[Docket No. FAA-2011-1115; Directorate Identifier 2010-SW-011-AD]

#### Airworthiness Directives; Sikorsky Aircraft Corporation (Sikorsky) Model S-92A Helicopters

**ACTION:** Notice of proposed rulemaking (NPRM).

**Airworthiness Directives; Sikorsky Aircraft Corporation (Sikorsky) Model S-92A Helicopters**

Figure 1. Cat 'A' Takeoff and Landing Gross Weight

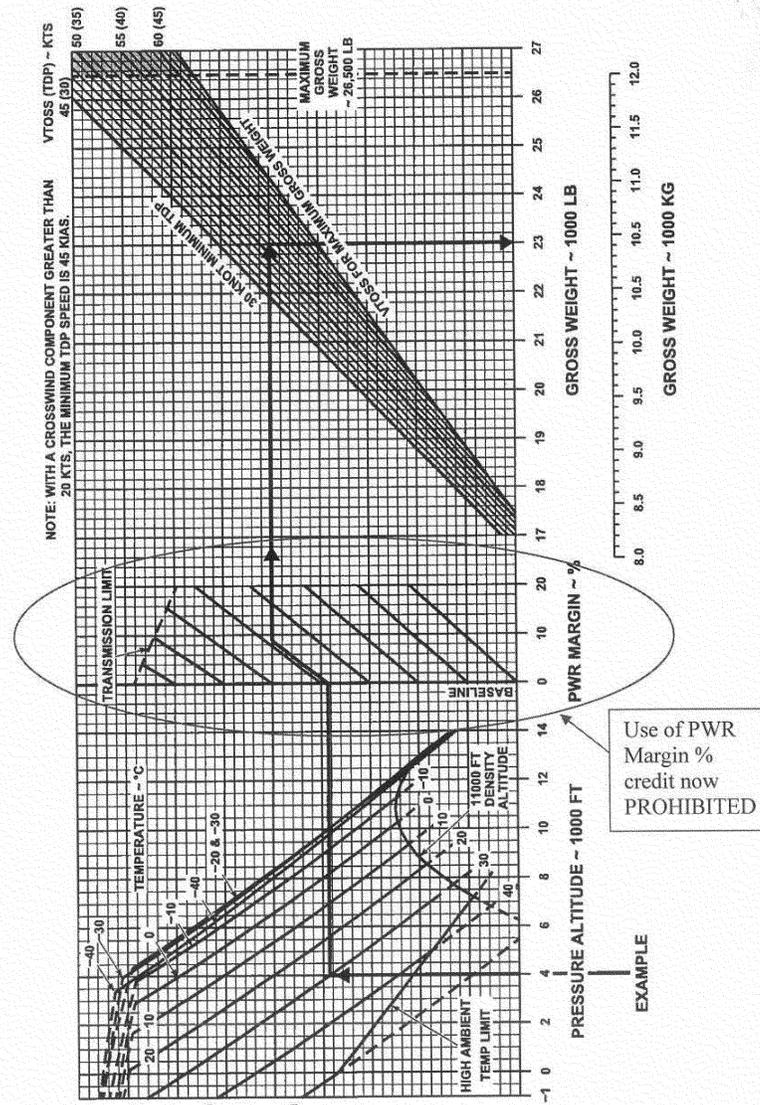
(b) If the RFM already contains the revisions appropriate for your helicopter as listed in the following Table 1, all dated April 9, 2008, with the correct performance charts, without the performance credit as depicted in the circled area of Figure 1 of this AD, the operating limitation required by paragraph (a) of this AD does not need to be inserted into the RFM.

**Note 1:** Previous RFM revisions allowed for the use of above-specification engine power margin as depicted in the circled area of Figure 1 of this AD.

(a) By making pen and ink changes, insert into the Operating Limitations section, Part 1, Section 1, *Weight Limits*, of RFM SA S92A-RFM-002, -003, -004, -005, and -006 the following limitation “Performance credit for above specification engine power margin is prohibited.”
